**PROPOSED REVISIONS TO TECHNICAL SPECIFICATION CHANGES ASSOCIATED WITH
PRESSURE-TEMPERATURE AND OVERPRESSURE PROTECTION SYSTEM
LIMITS FOR UP TO 13.3 EFFECTIVE FULL POWER YEARS**

NEW YORK POWER AUTHORITY
INDIAN POINT 3 NUCLEAR POWER PLANT
DOCKET NO. 50-286
DPR-64

**SAFETY EVALUATION OF REVISED
PROPOSED TECHNICAL SPECIFICATION CHANGES ASSOCIATED WITH
PRESSURE-TEMPERATURE AND OVERPRESSURE PROTECTION SYSTEM
LIMITS FOR UP TO 13.3 EFFECTIVE FULL POWER YEARS**

**MARK-UP OF REVISED TECHNICAL SPECIFICATION PAGES ASSOCIATED WITH
AMENDMENT REQUEST FOR PROPOSED TECHNICAL SPECIFICATION CHANGES
ASSOCIATED WITH PRESSURE-TEMPERATURE AND OVERPRESSURE PROTECTION
SYSTEM LIMITS FOR UP TO 13.3 EFFECTIVE FULL POWER YEARS**

FIGURE 3.1.A-1
MAXIMUM PERMISSIBLE Tcold FOR FIRST RCP START
(OPS OPERABLE, HOTTEST SG TEMP > Tcold)

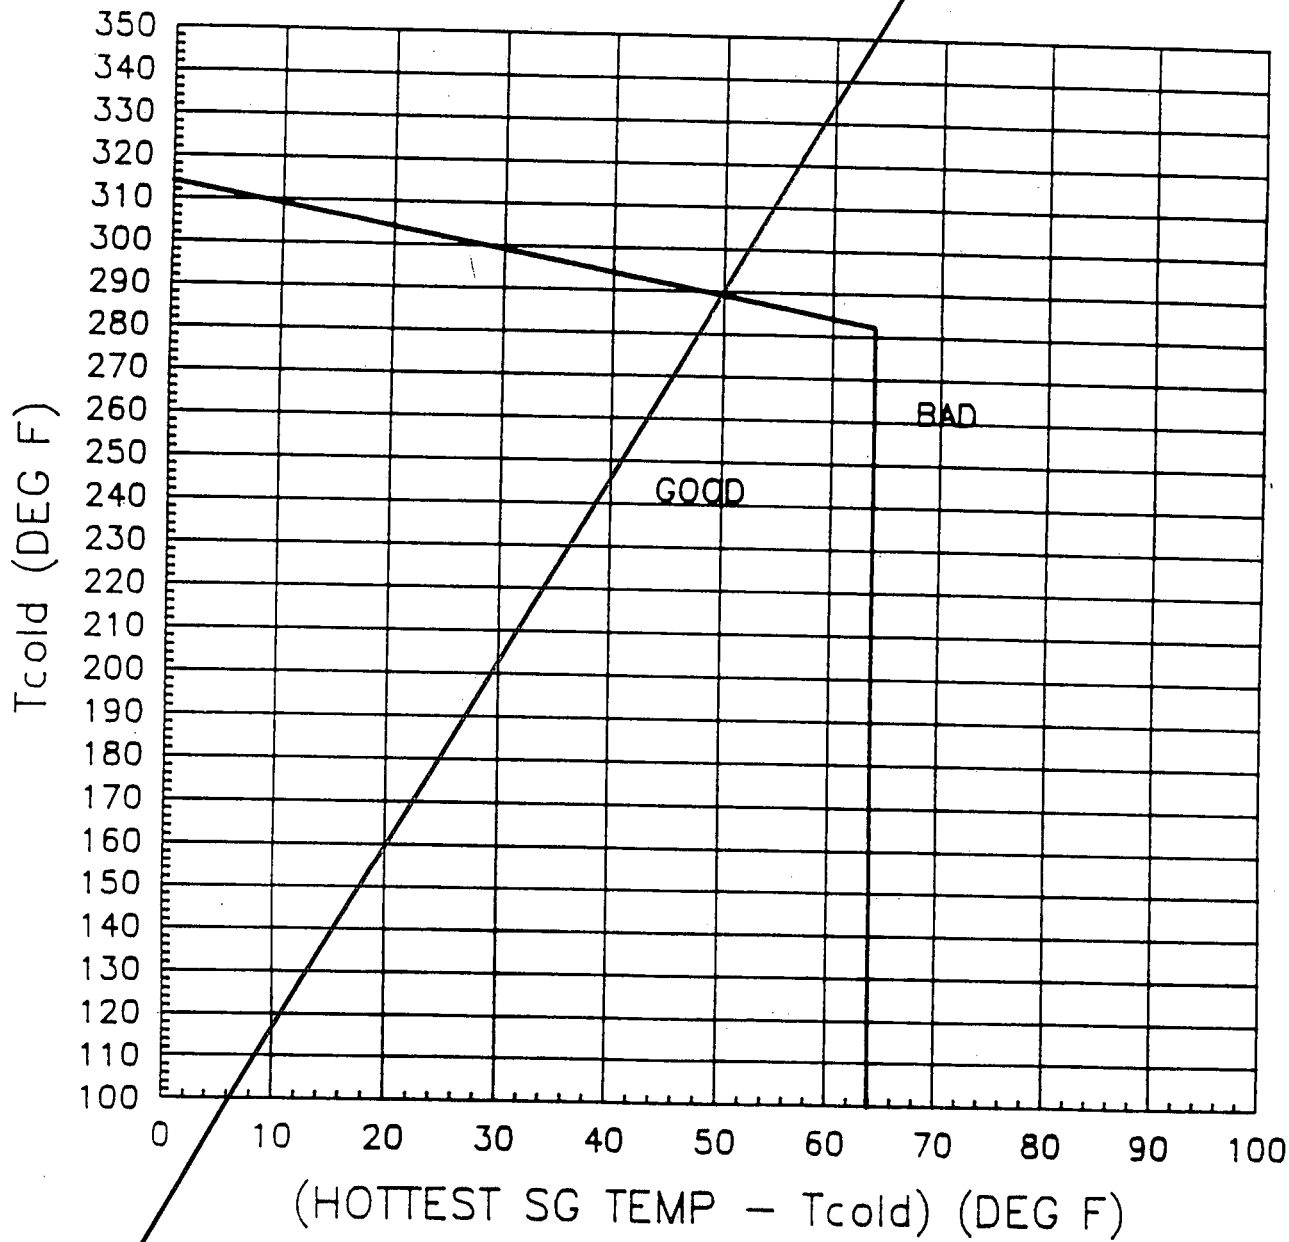
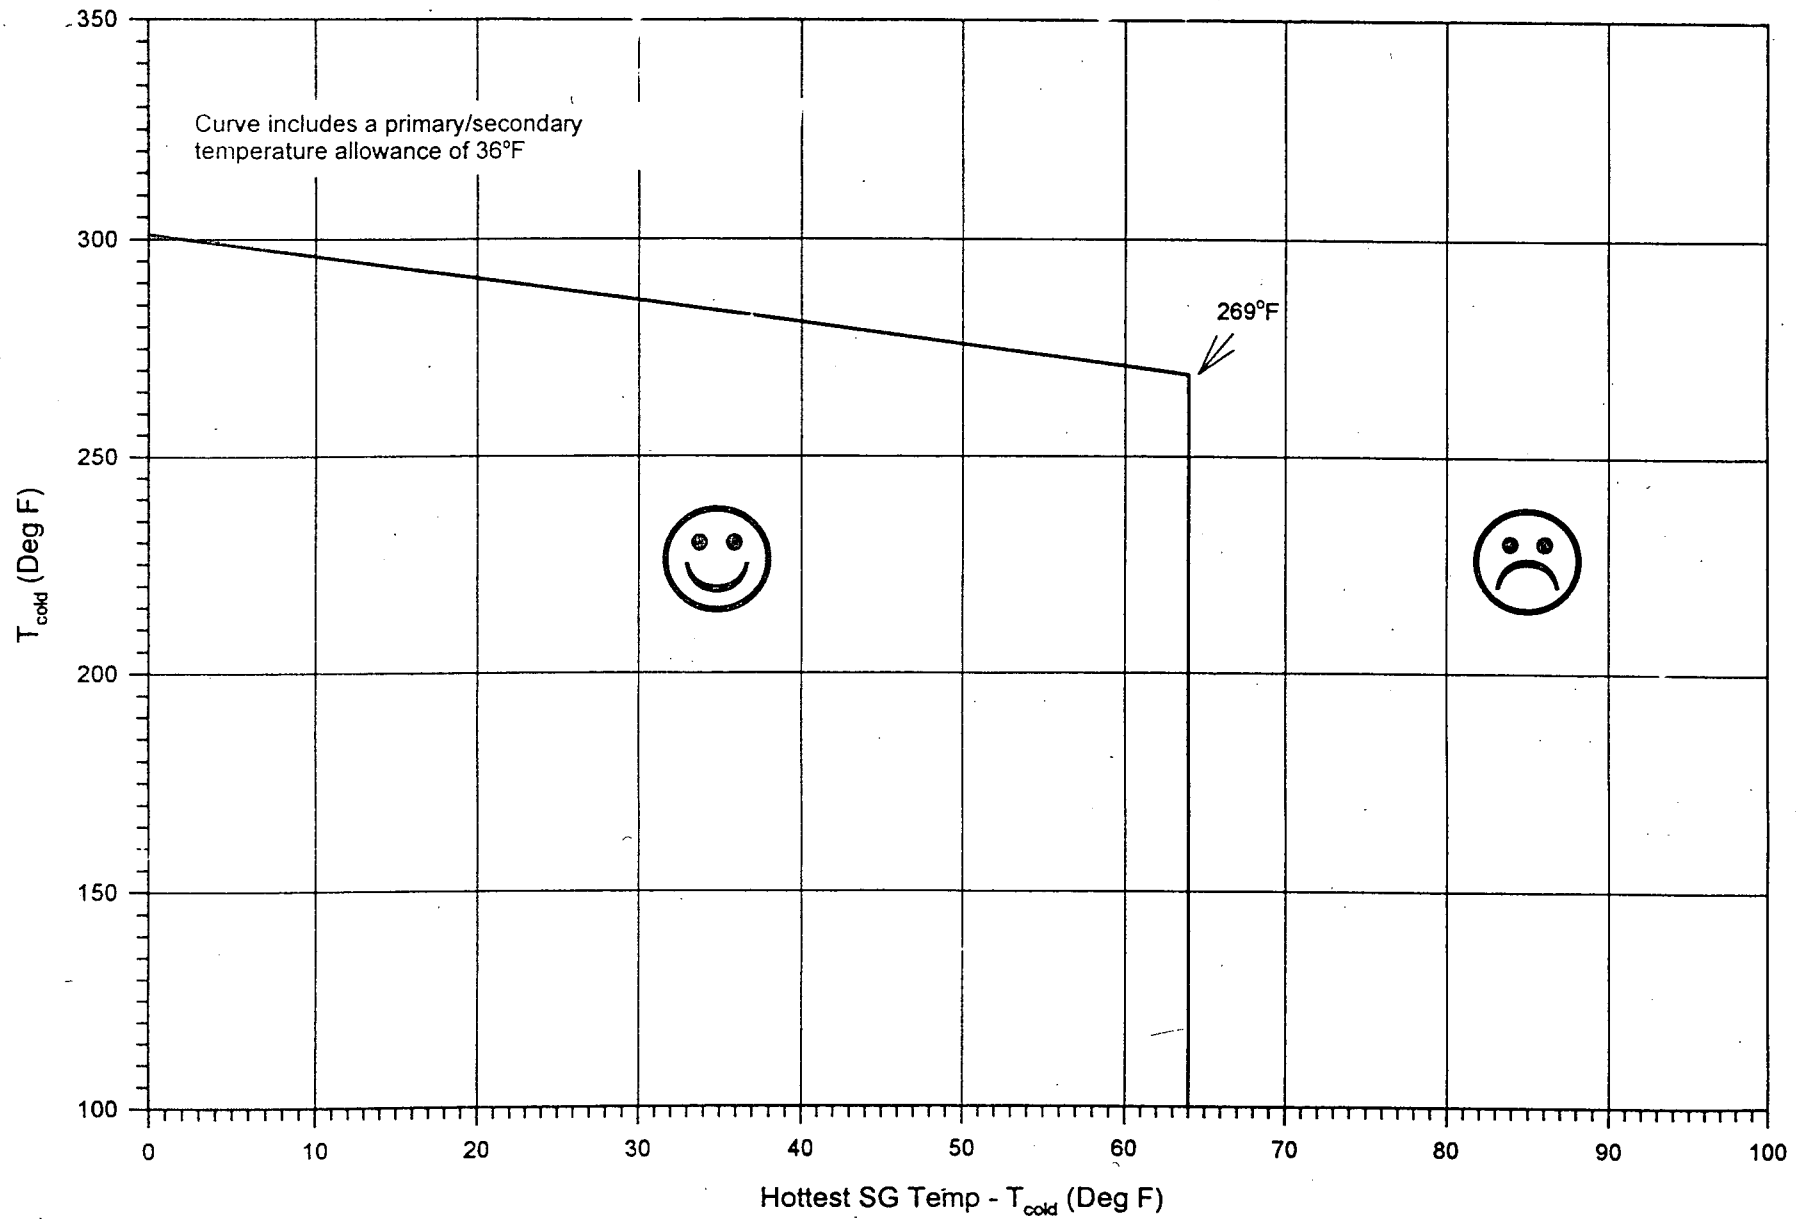
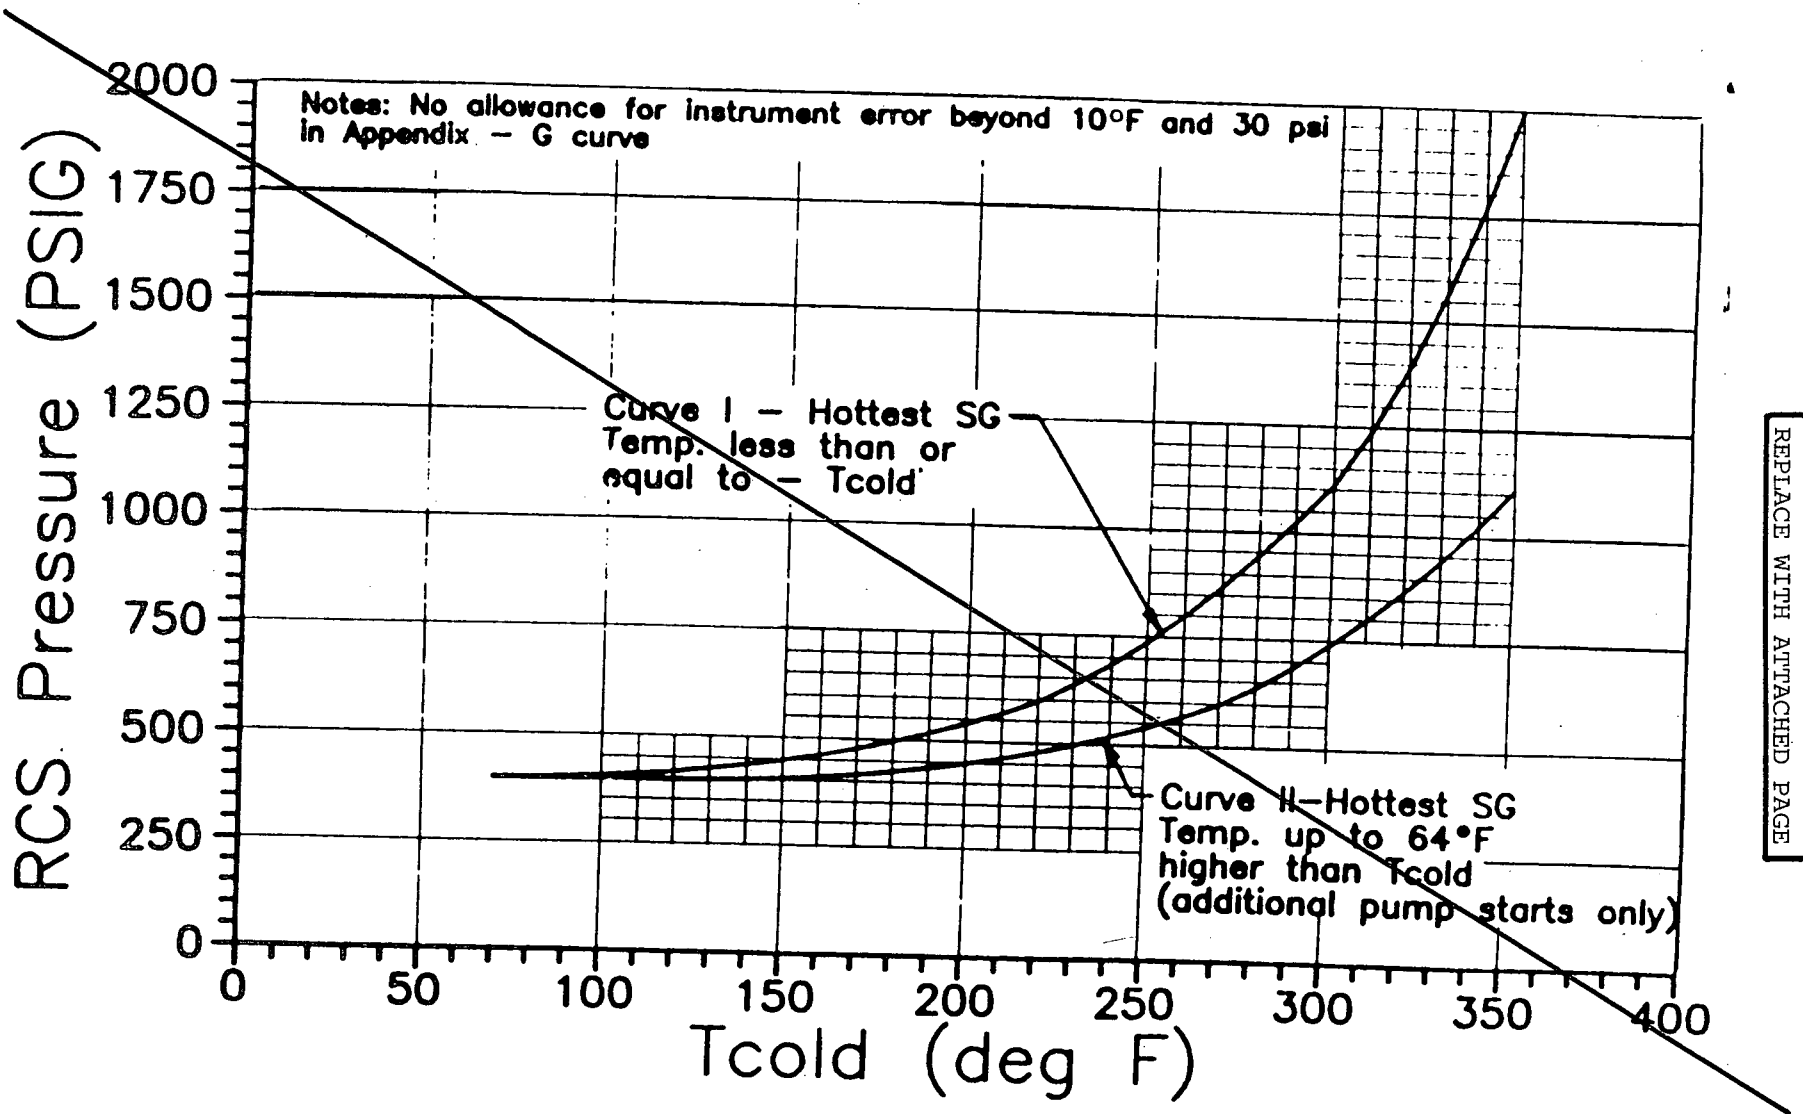
- Or
- (2) The OPS is operable, the temperature of the hottest steam generator exceeds the coldest T_{cold} by no more than 64°F, pressurizer level is at or below ~~75~~ 73 percent, and T_{cold} is as per Figure 3.1.A-1;

Secondary Side Limitations for RCP Start With
Secondary Side Hotter Than Primary, 13.3 EFPY

Figure 3.1.A-2

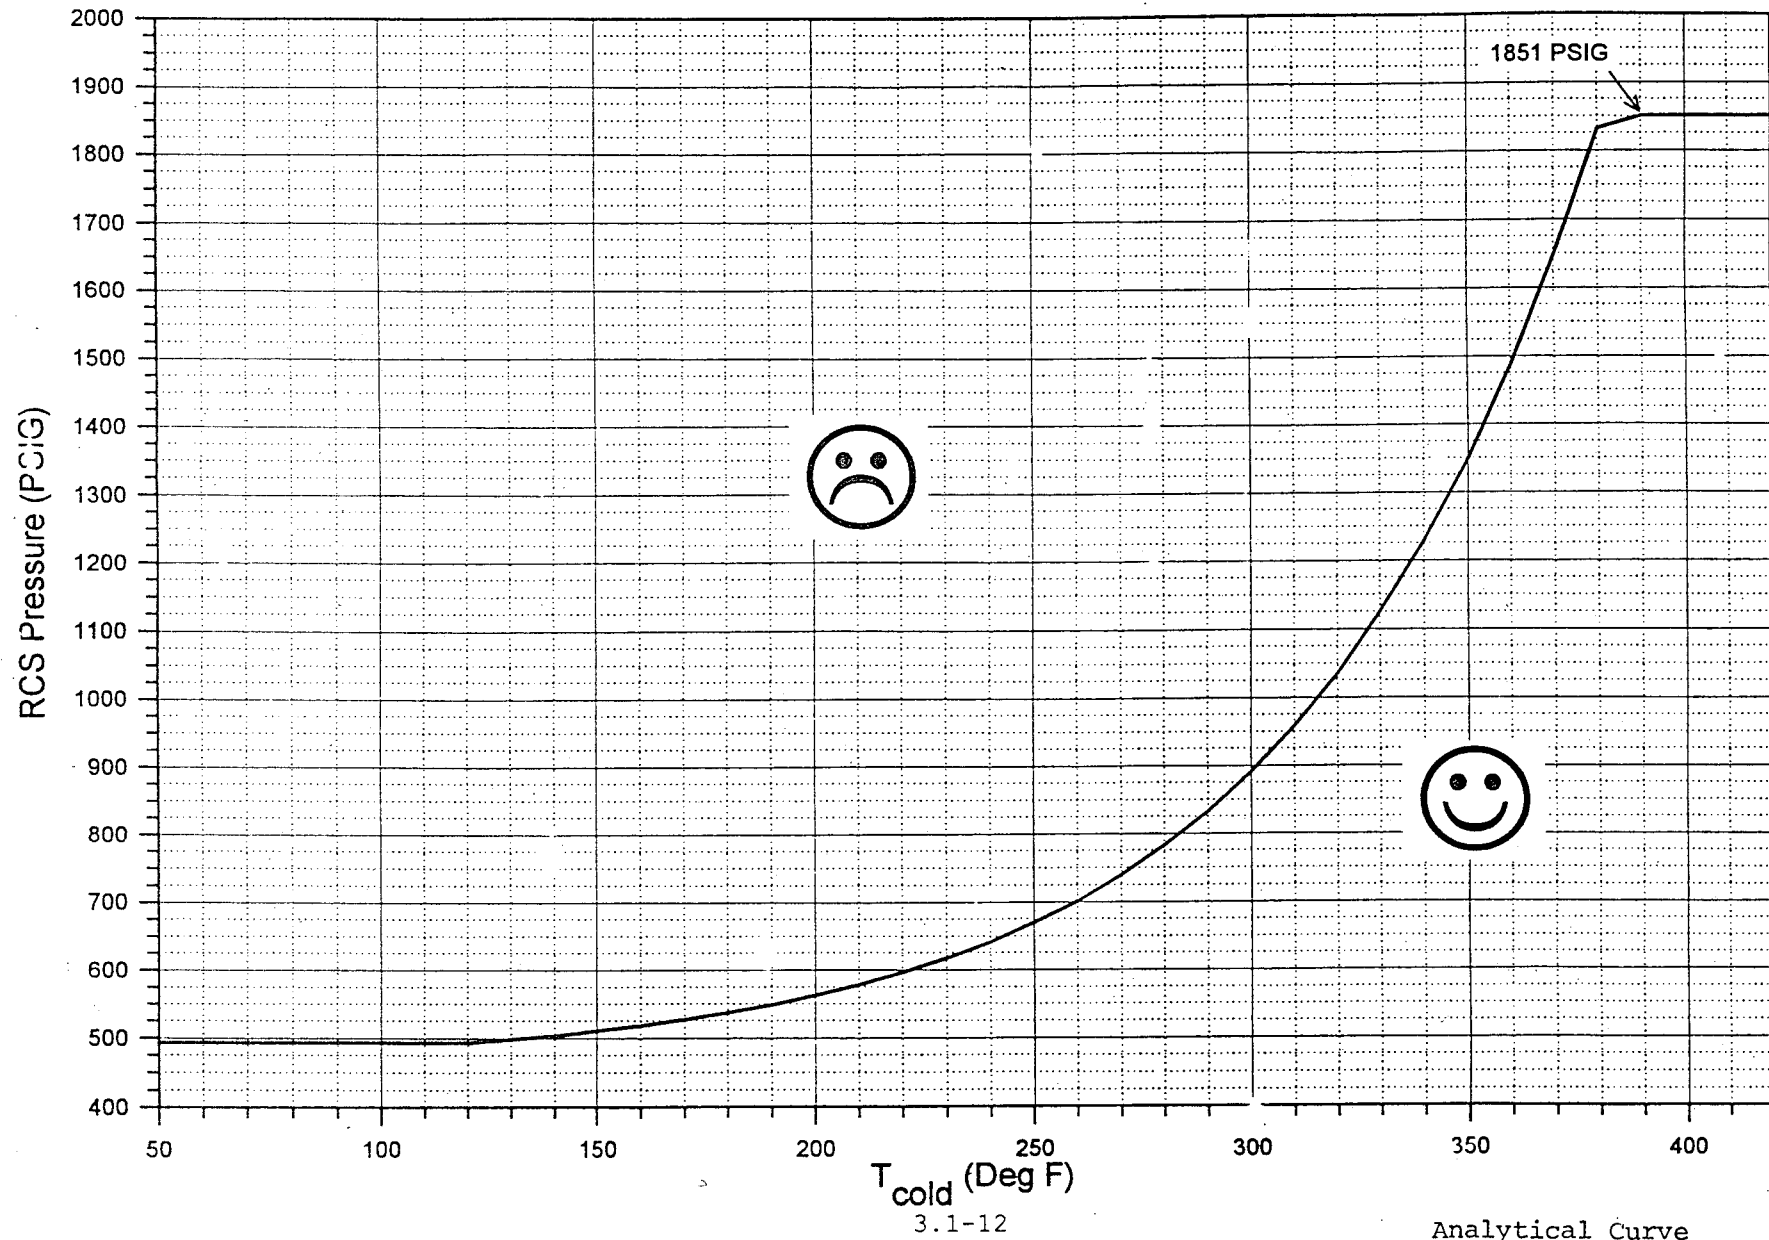
- ~~i. Additional pumps may not be started (or jogged) unless the OPS is operable and the pressurizer level is not increasing.~~
- ~~(1) Specification 3.1.A.1.i above may be modified to allow the OPS inoperable, providing the temperature of each steam generator has remained less than or equal to the coldest T_{cold} since the first RCP start, pressurizer level is at or below 75 percent and the RCS pressure does not exceed that given by Curve I on Fig. 3.1.A-2.~~

- ~~(2) Specification 3.1.A.1.i above may be further modified to allow the OPS inoperable and the temperature of the hottest steam generator to be no greater than 64°F higher than the coldest T_{cold} , provided that pressurizer level is at or below 75 percent and RCS pressure does not exceed that given by Curve II on Fig. 3.1.A-2.~~

Maximum Allowable Nominal PORV Setpoint for the
Low Temperature Overpressure Protection System (OPS), 13.3 EFPY

FIGURE 3.1.A-4

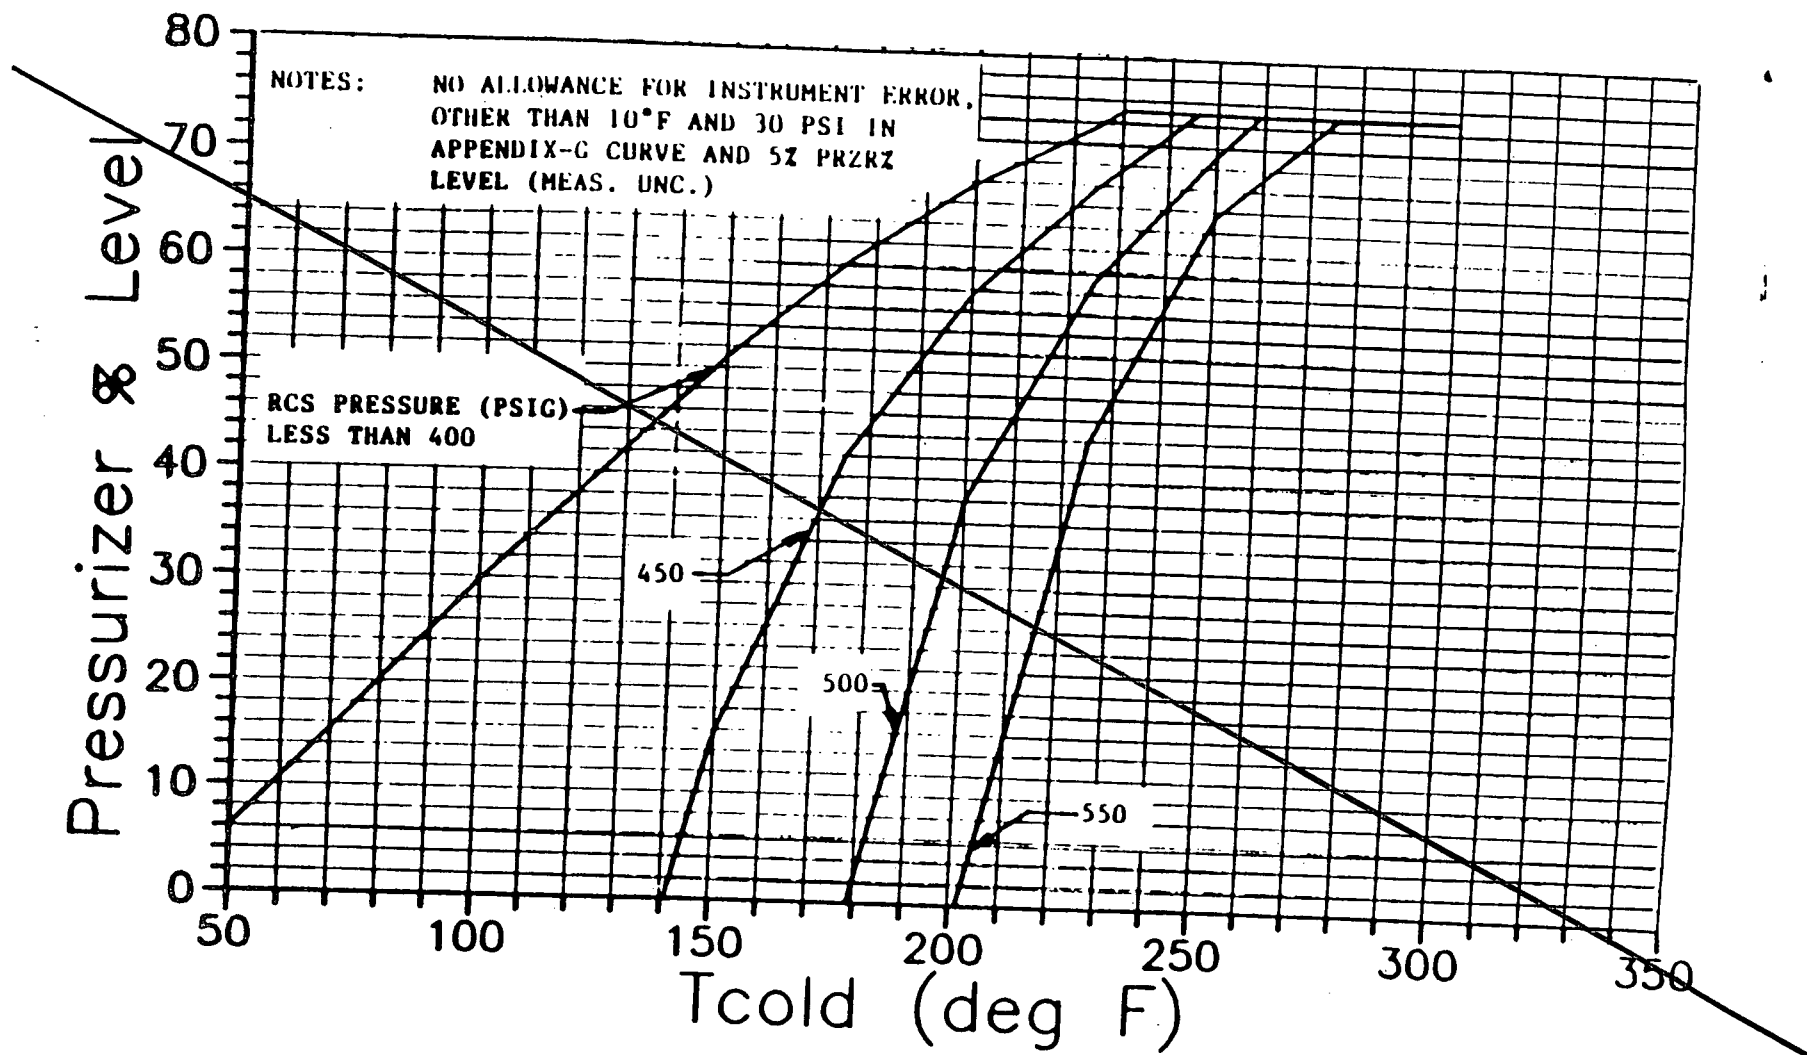
~~RCS PRESSURE LIMITS FOR LOW TEMPERATURE OPERATION~~

~~MAXIMUM PRESSURIZER LEVEL FOR OPS INOPERABLE AND FIRST RCP START
(STEAM GENERATOR TEMPERATURE GREATER THAN Tcold)~~

DELETED
